**CITY OF CEDARBURG  
A MEETING OF THE PLAN COMMISSION  
MONDAY, FEBRUARY 2, 2026 – 7:00 PM**

- C. Public hearing, discussion, and possible action on the request of applicant DSDH Gerb LLC, in c/o Dave Herbeck of Herbeck Development, for Conditional Use Permit approval to develop a 16,617 sq. ft. motor vehicle collision repair facility on the vacant, 1.84-acre, M-2 General Manufacturing zoned site located at the northwest corner of Sommerset Avenue and Pioneer Road. The property owner is Pioneer Real Estate Development LLC in c/o Mike LaRosa.

# PLANNER REPORT

DESIGNED MPK	DRAWN MPK
PROJECT NO. D0911 092500688	
DATE DECEMBER 19, 2025	
SHEET NO. <b>C105</b>

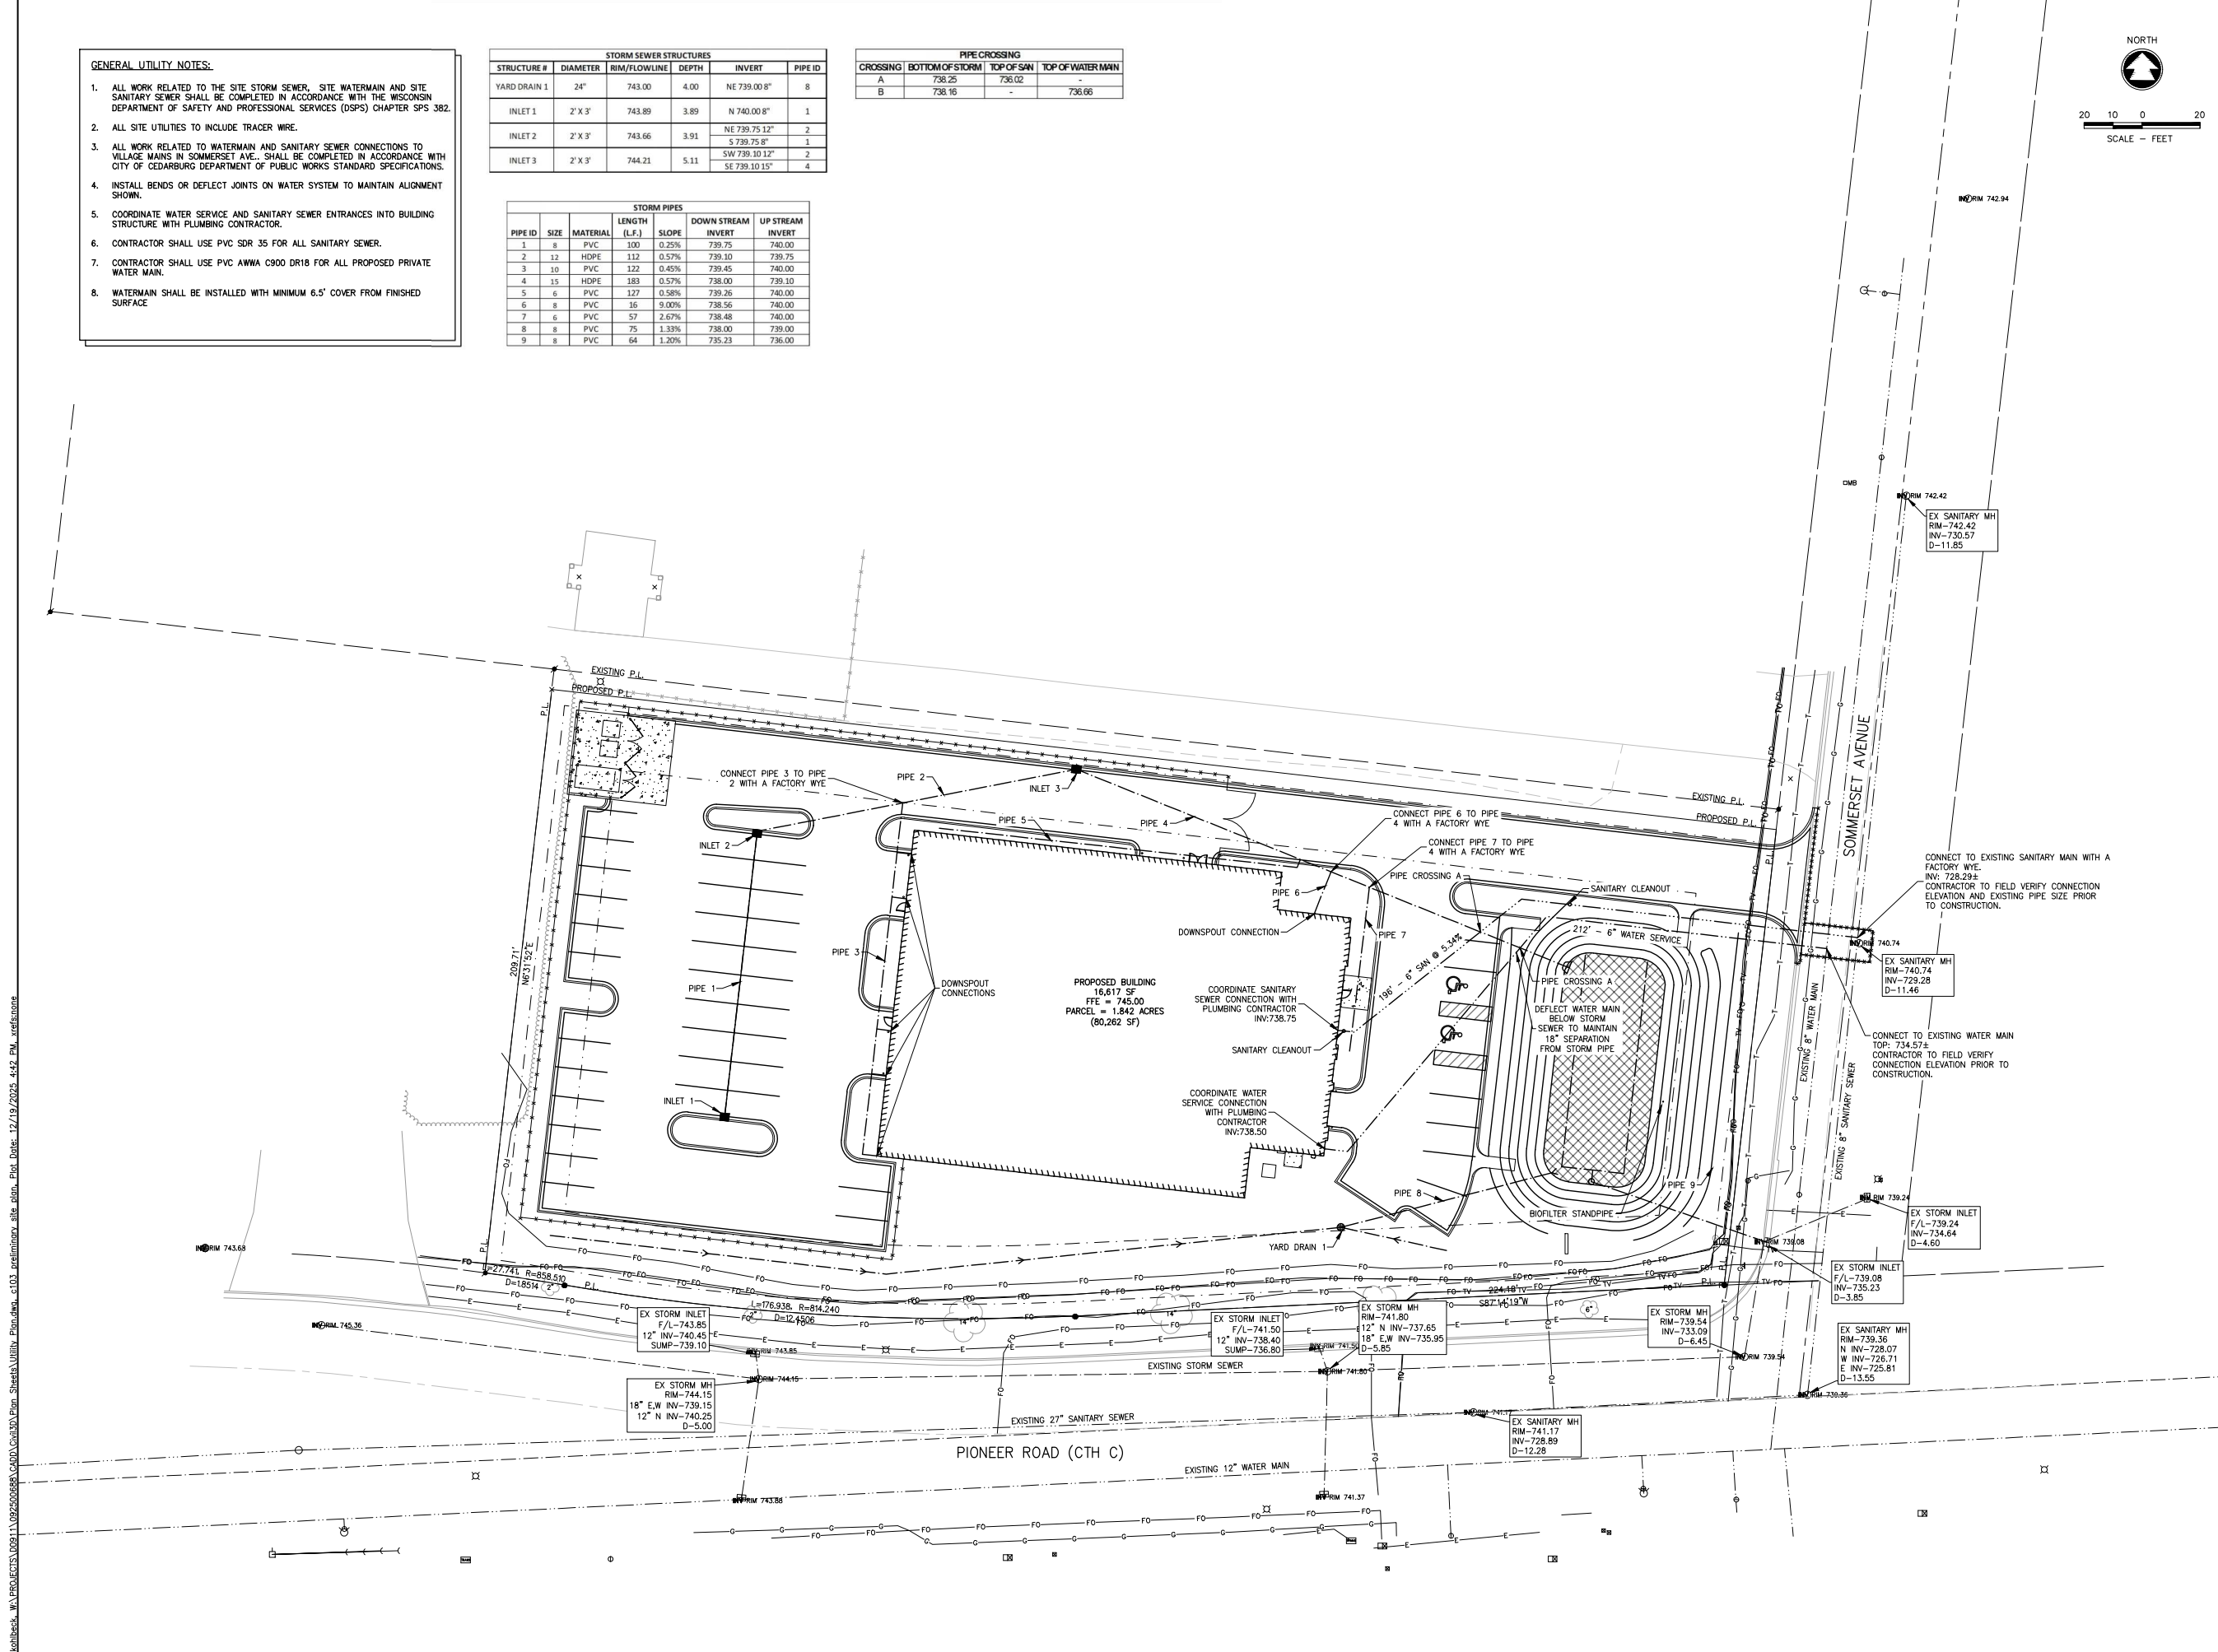
- Timothy D. Martin, Water Utility Superintendent / Cedarburg Light and Water Utility
  - The 6" H2O service shall be connected to the existing 8" PVC water main in Somerset using a tapping saddle with a 6" gate valve attached at the main. Only other concern is the route being right on the edge of the retention pond downslope. Verify adequate cover is maintained. All other L&W construction specifications shall be adhered to.

- Mike Wieser, P.E., Director of Engineering & Public Works
  - Stormwater Management Plan must be approved by the City.
  - Side slopes of biofilter should be planted with turf grass that is mowed weekly with other turf grass.
  - I am ok with the sewer lateral to Sommerset as long as it's in the same trench as the water lateral.
  - Connections to PVC sewer main must be made with PVC fittings.
  - Slurry backfill in the roadway.
  - Replace 5 inches of asphalt in trench.

## PLANT SCHEDULE

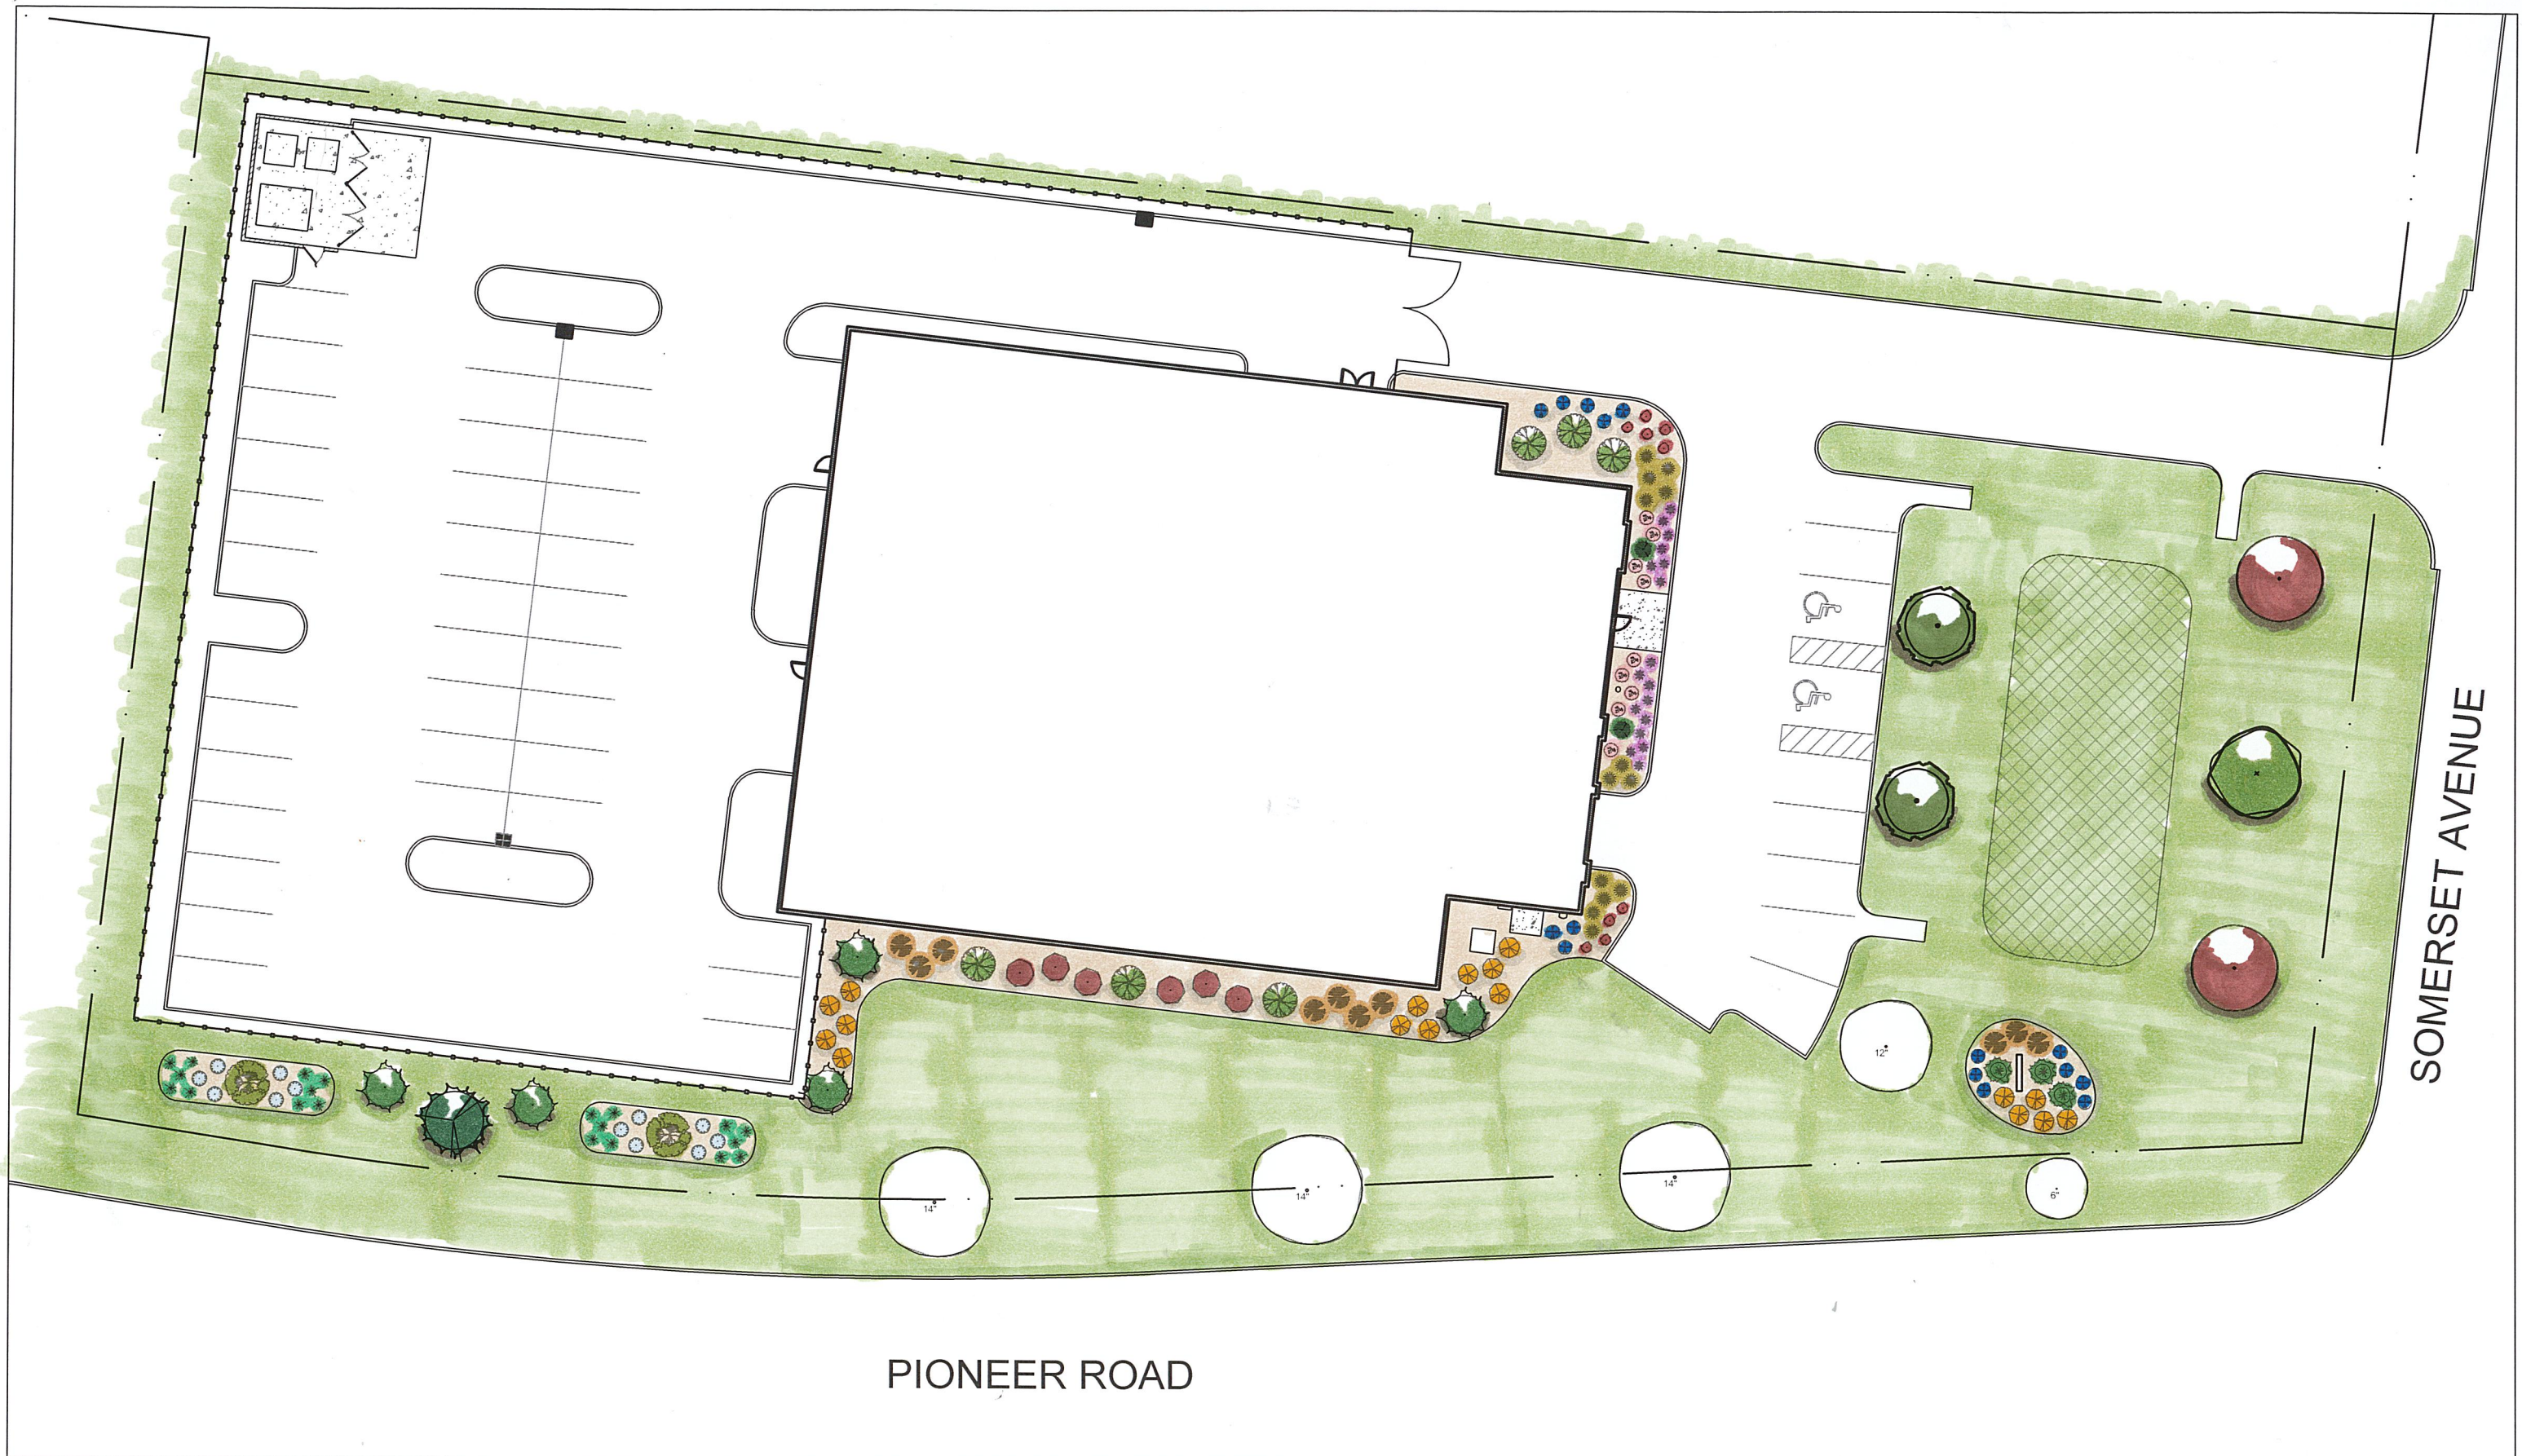
- There are six (6) City-owned right-of-way trees along Pioneer Rd., next to the proposed construction area (attached). Only four (4) of them are identified on their (the applicants) Planting Schedule. They are identified as Existing to Remain on the Plant Schedule. I ask that the Developer identify all six (6) public trees on their site plans with plans to retain. Please see attached Highlighted Excerpt form Policy PR-6 (attached).
